Attachment G
Exceptions to Design Standards

Fact Sheet Exceptions to Mandatory Design Standards

LAUREN PROCTOR, Registered Civil Engineer
CH2M HILL

ATTACHMENT 16

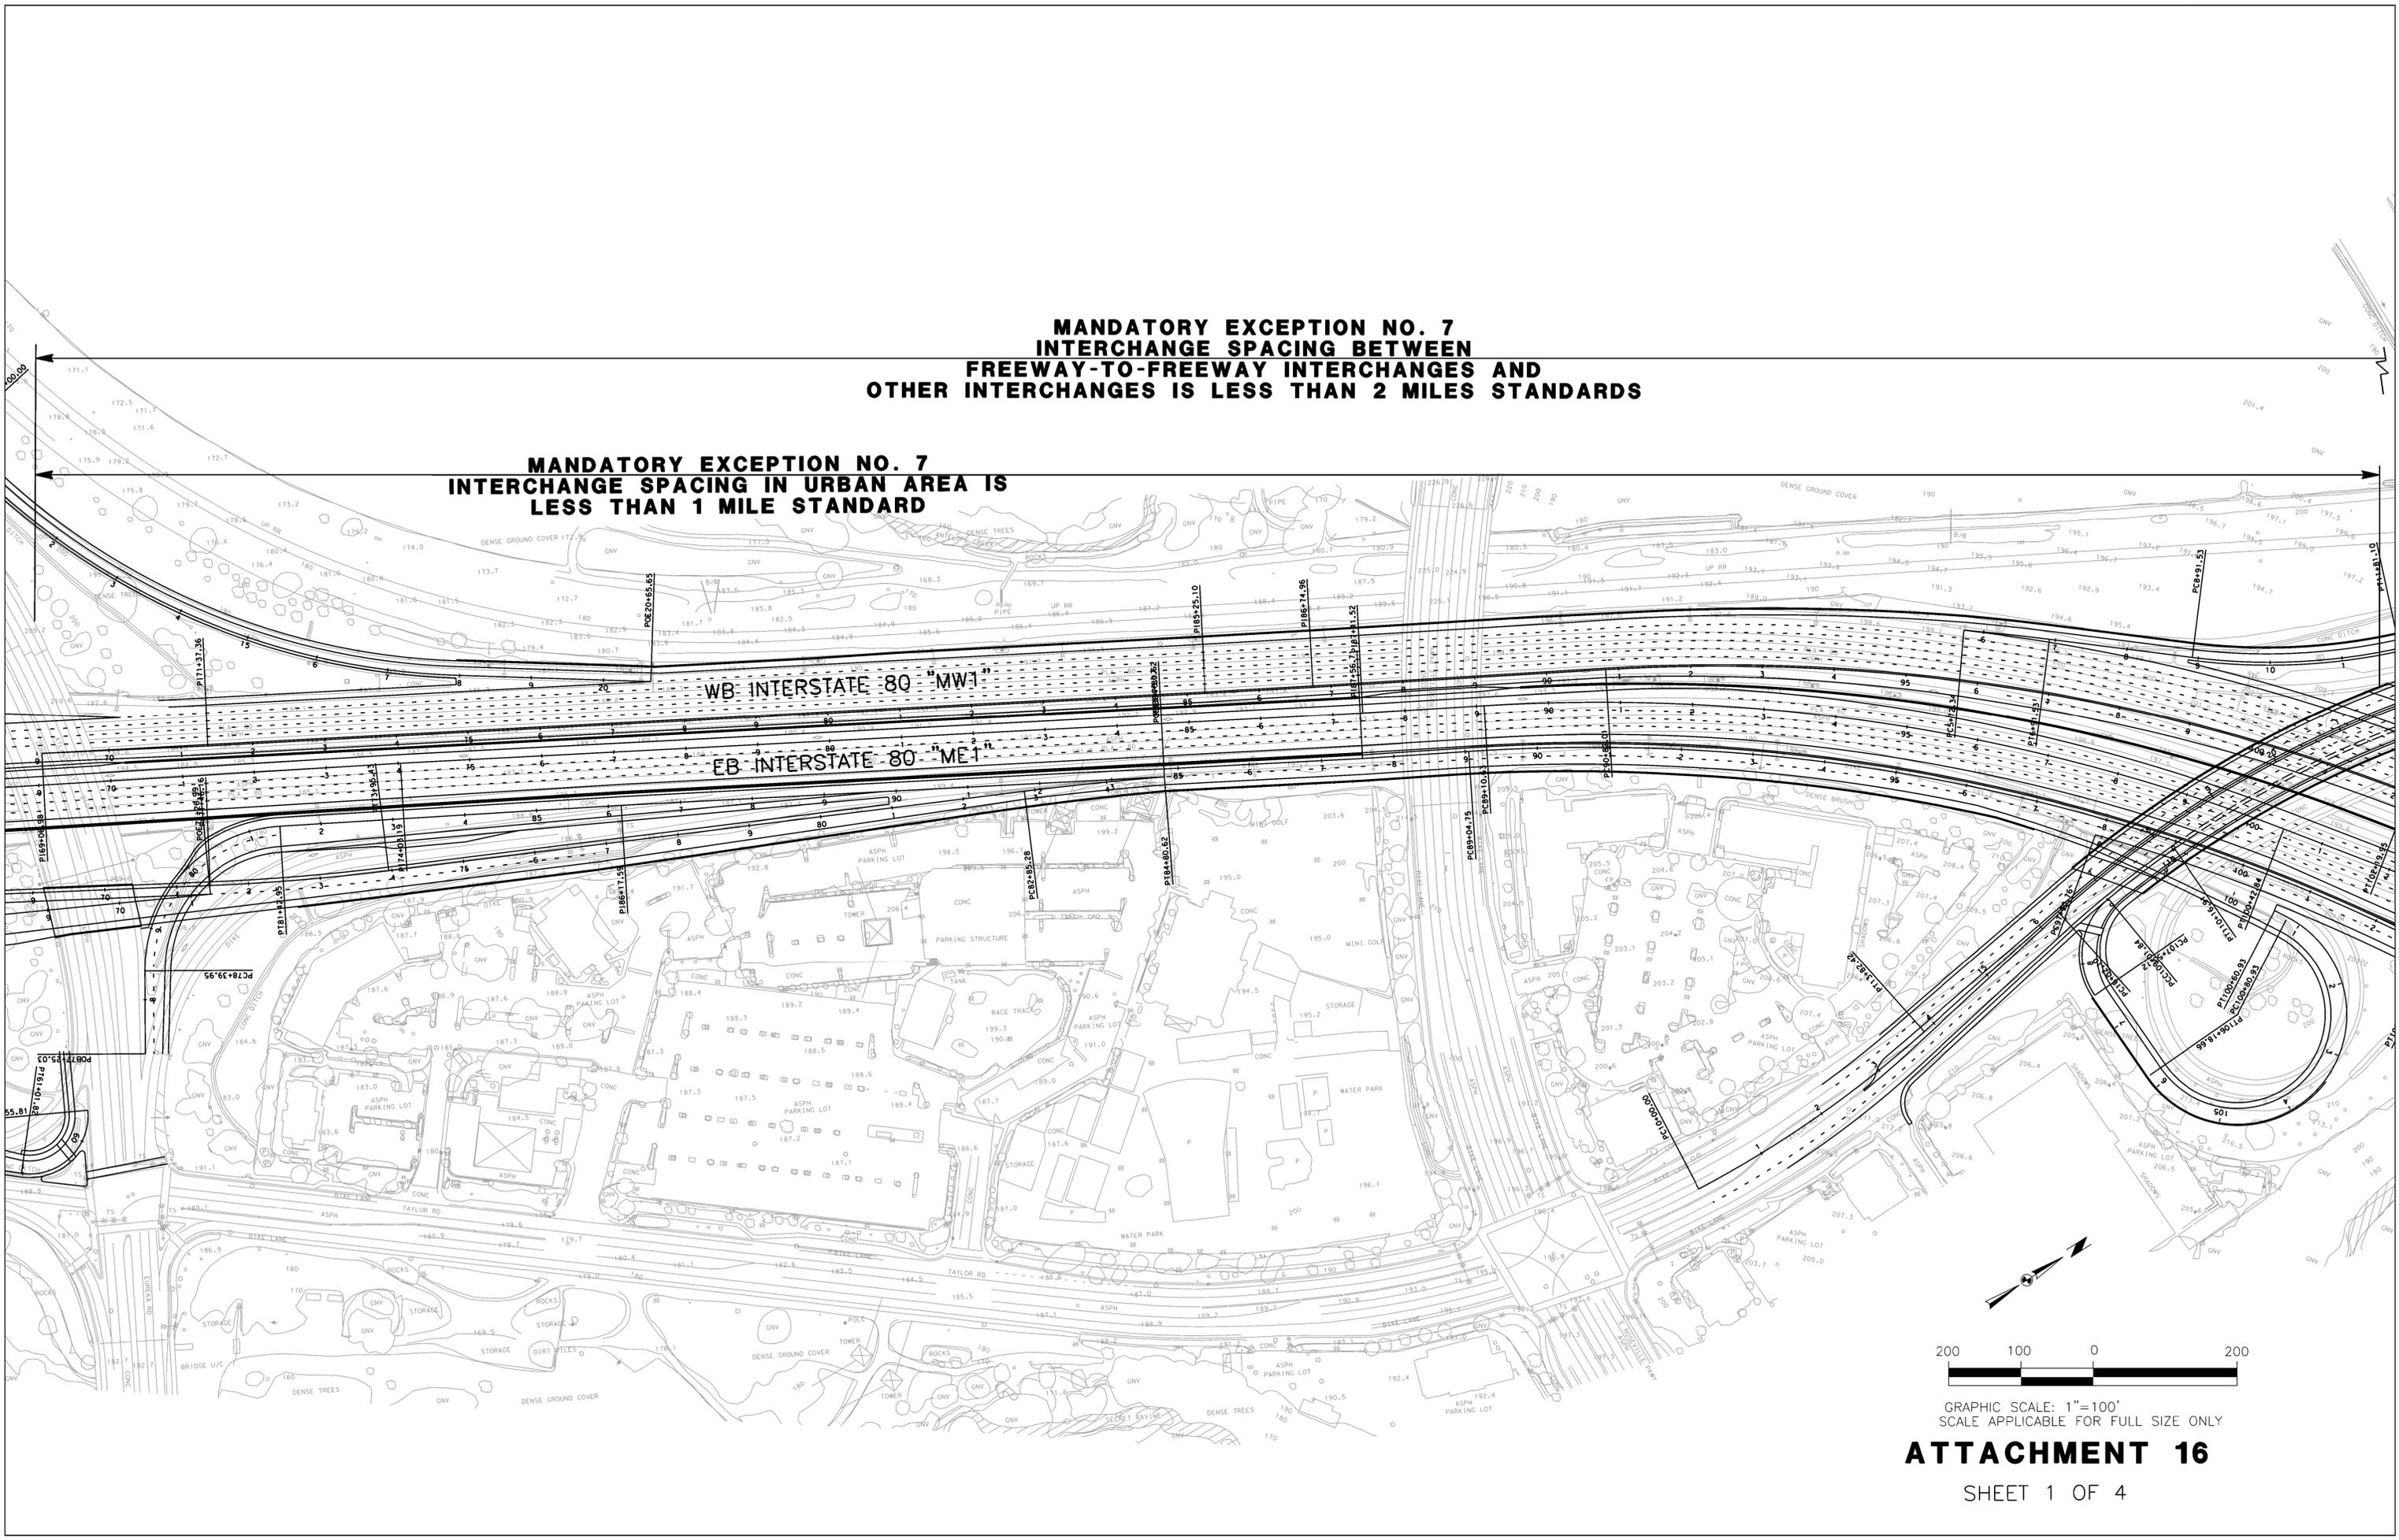
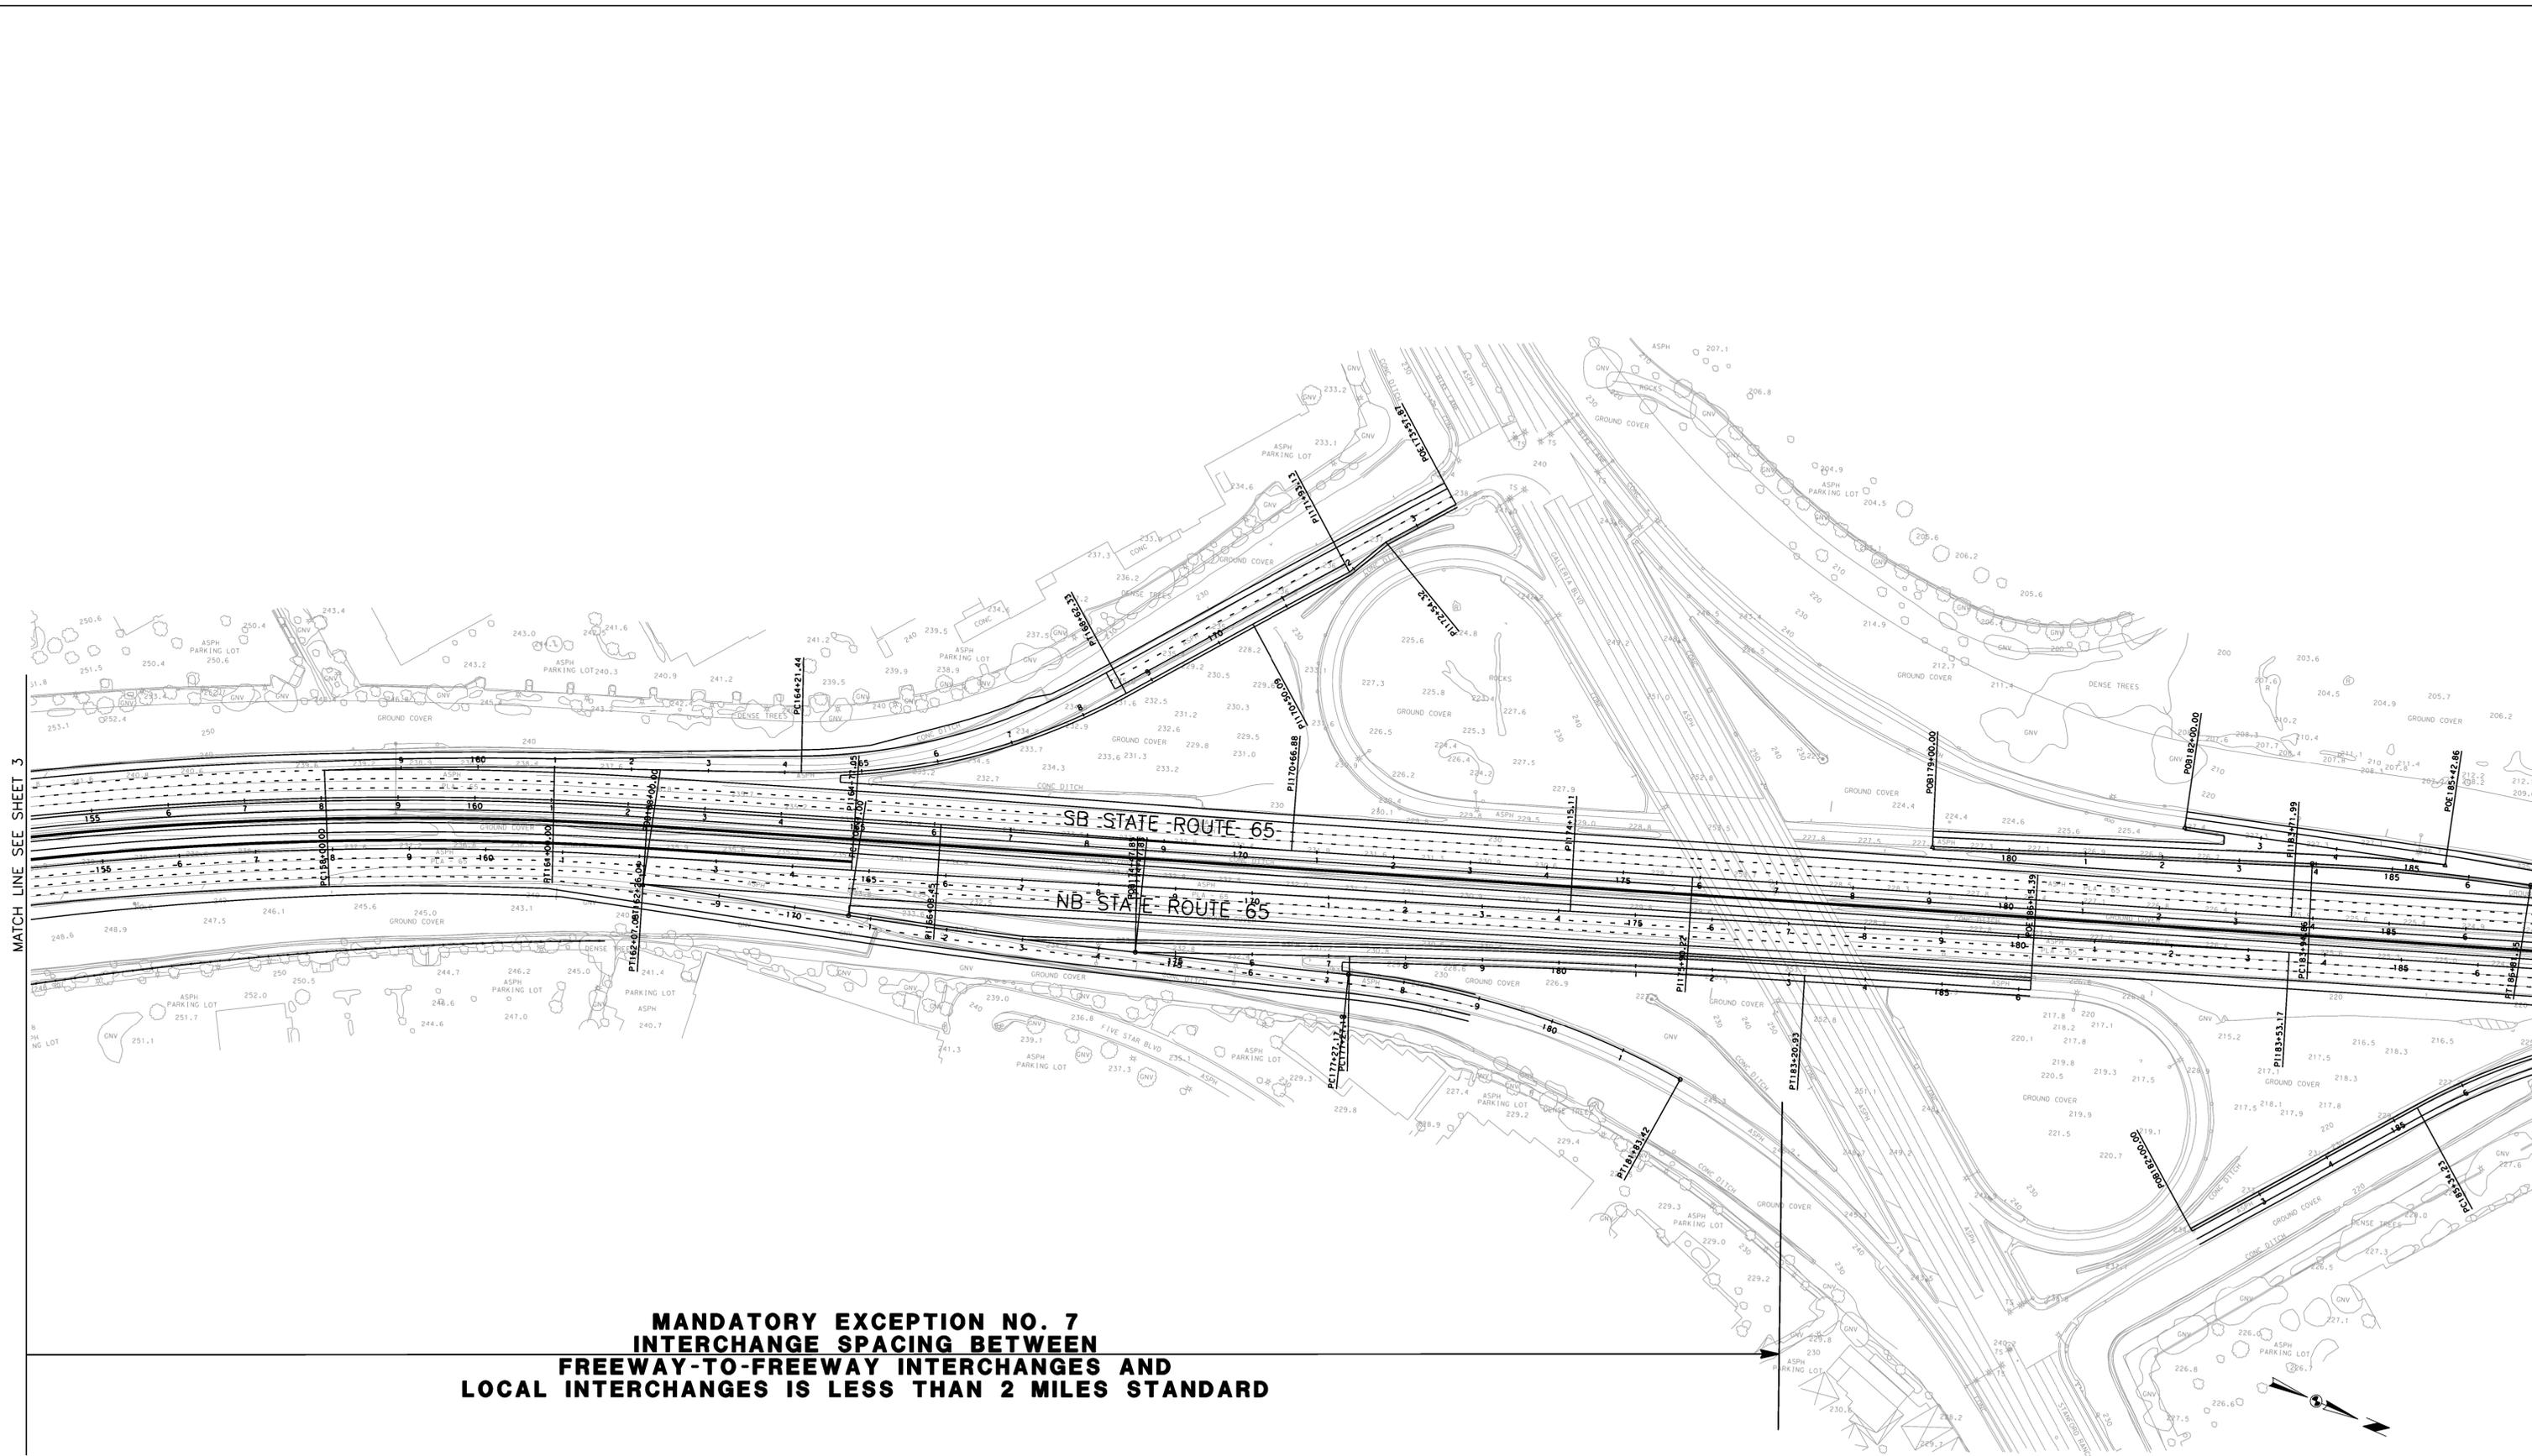
Below is the list of non-standard spacing between interchanges (See Attachment 16):

- Eureka Rd/Atlantic St I/C to Taylor Rd I/C: 0.6 mile
- Eureka Rd/Atlantic St I/C to I-80/SR 65 I/C: 1.1 mile
- Taylor Rd I/C to I-80/SR 65 I/C: 0.5 mile
- Galleria Blvd/Stanford Ranch Rd I/C to I-80/SR 65 I/C: 1.0 mile

**MANDATORY EXCEPTION NO. 7
INTERCHANGE SPACING BETWEEN
FREEWAY-TO-FREEWAY INTERCHANGES AND
OTHER INTERCHANGES IS LESS THAN 2 MILES STANDARDS**

**MANDATORY EXCEPTION NO. 7
INTERCHANGE SPACING IN URBAN AREA IS
LESS THAN 1 MILE STANDARD**

The proposed spacing between these interchanges are the same as the current condition.

Conformance to standard would require the following:

**ADVISORY EXCEPTION NO. 4C
COMPOUND CURVE HAS R=860' LESS THAN
2/3 OF R=2985' AND THE SMALLER RADIUS
FOLLOW THE LARGER RADIUS**

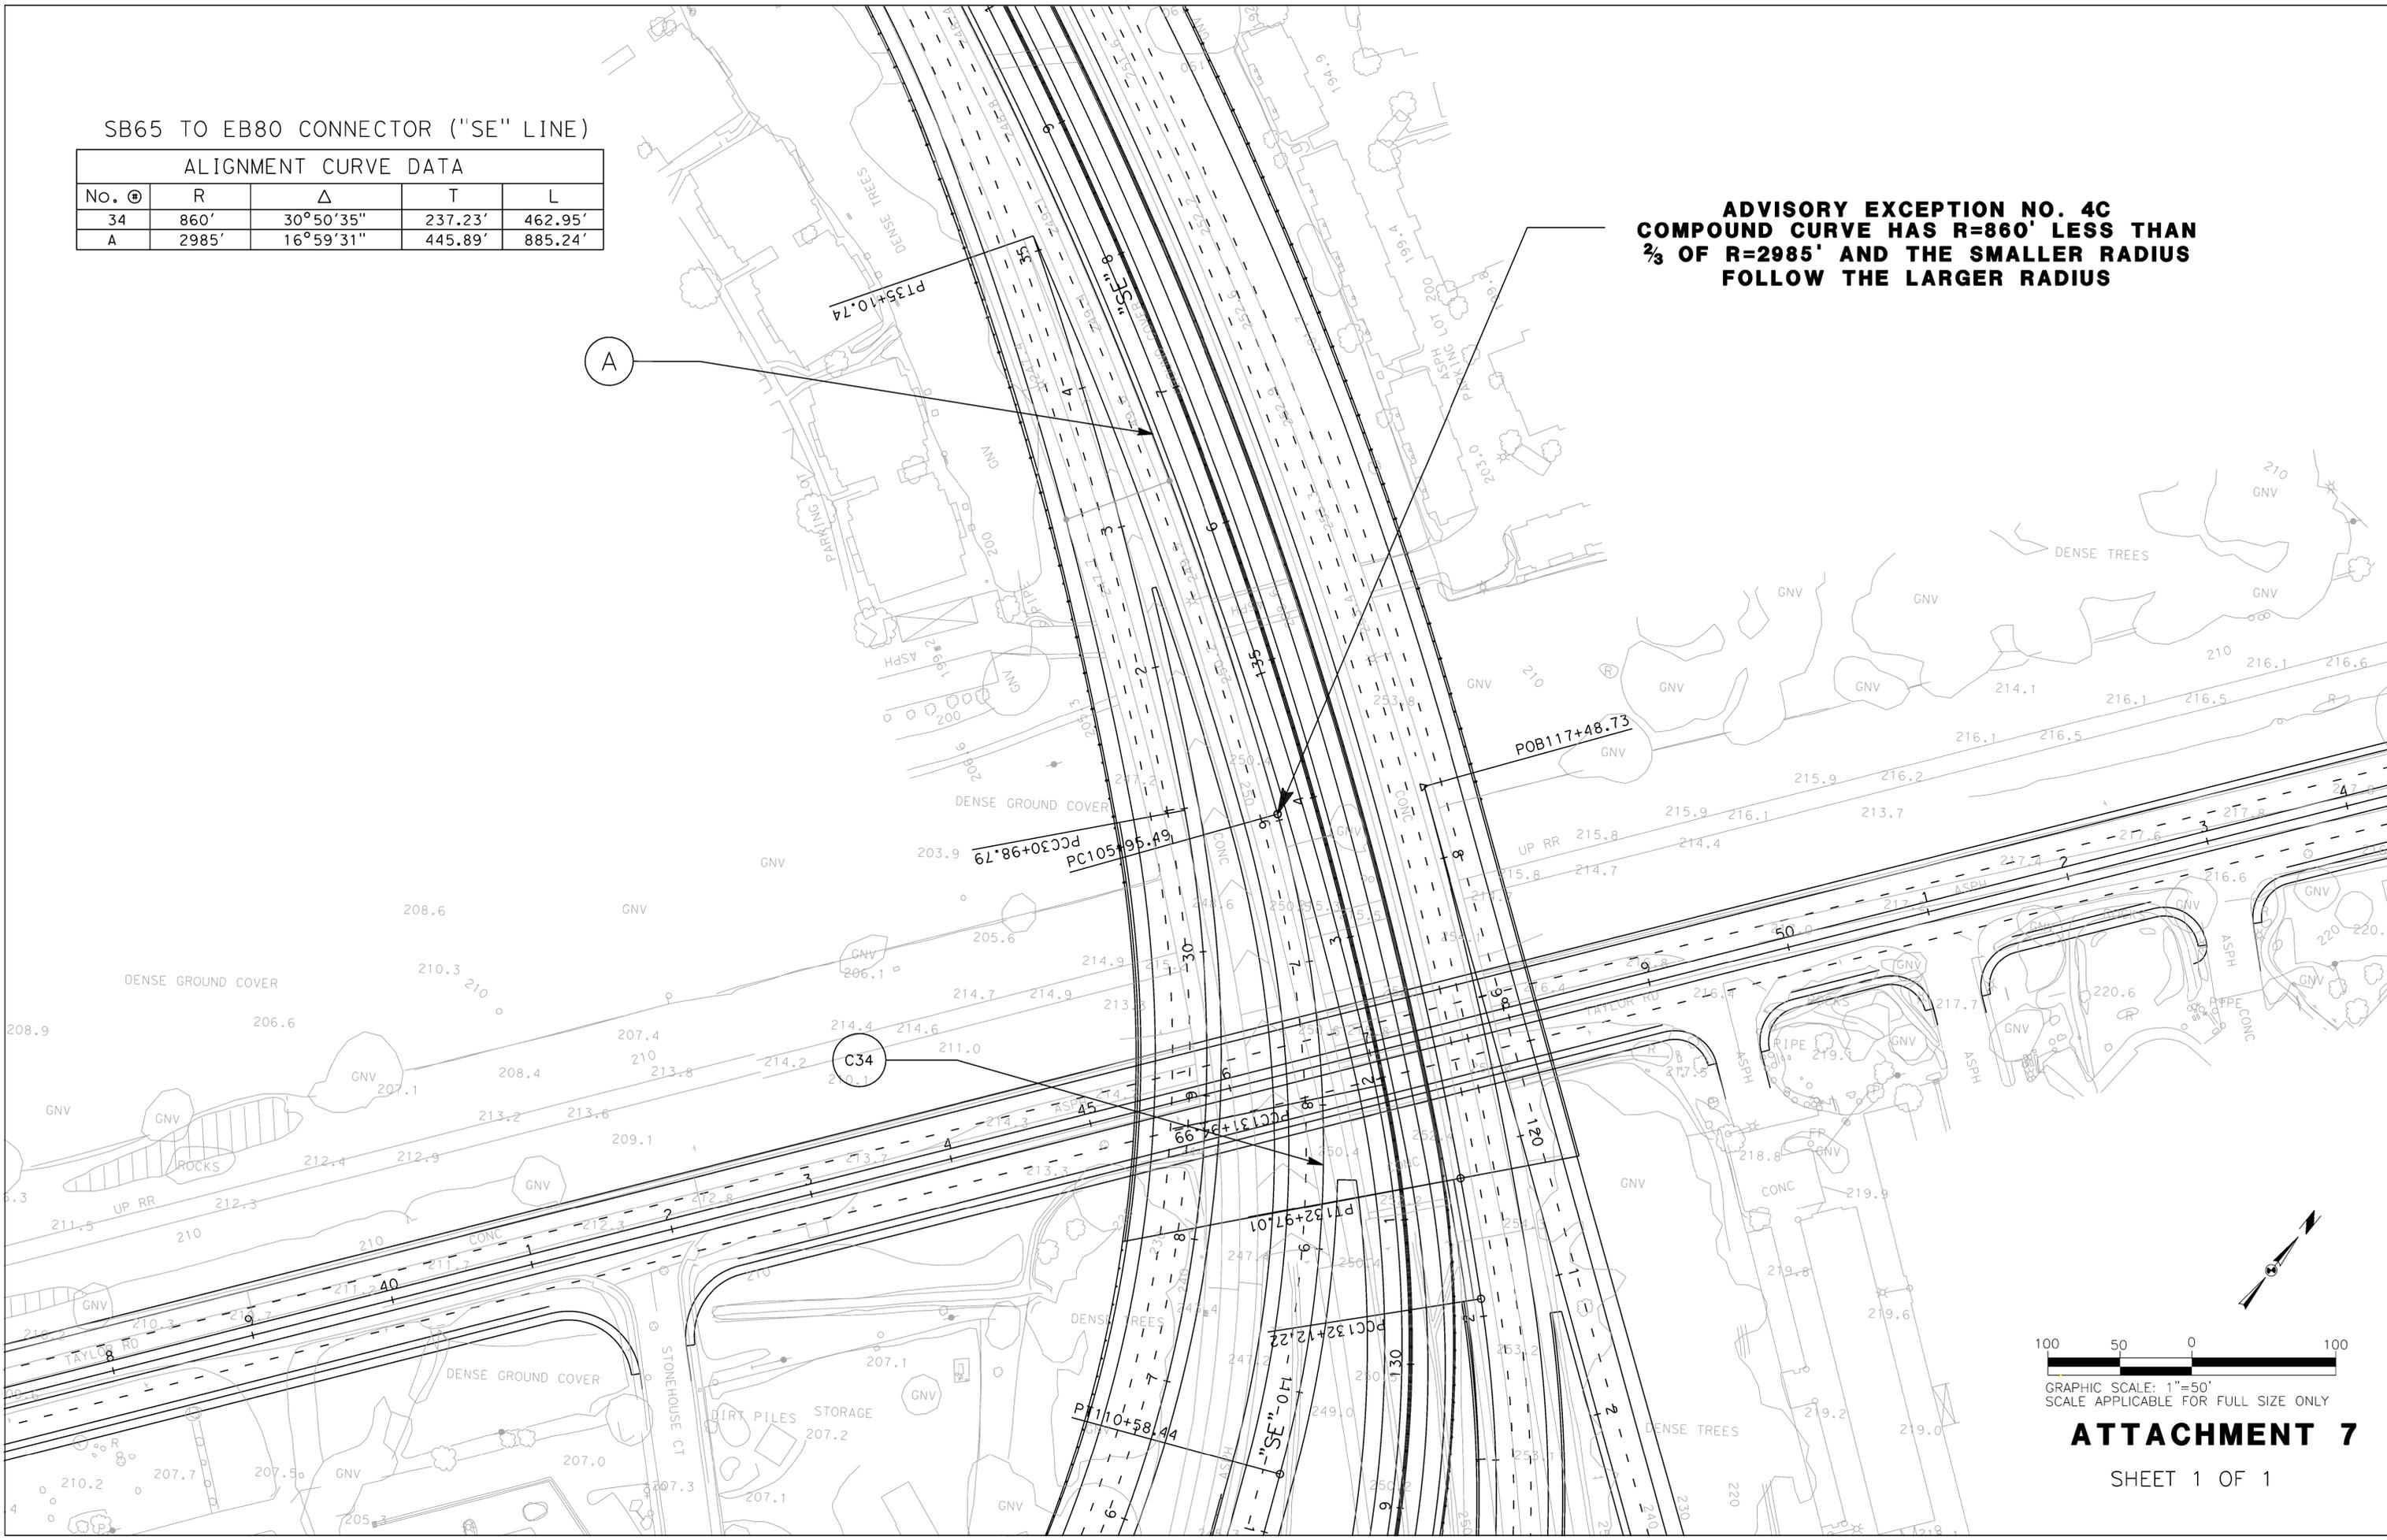
**ADVISORY EXCEPTION NO. 4D
 COUMPOUND CURVE HAS R=930' LESS
 THAN 2/3 OF 2750' AND THE SMALLER RADIUS
 FOLLOWS THE LARGER RADIUS**
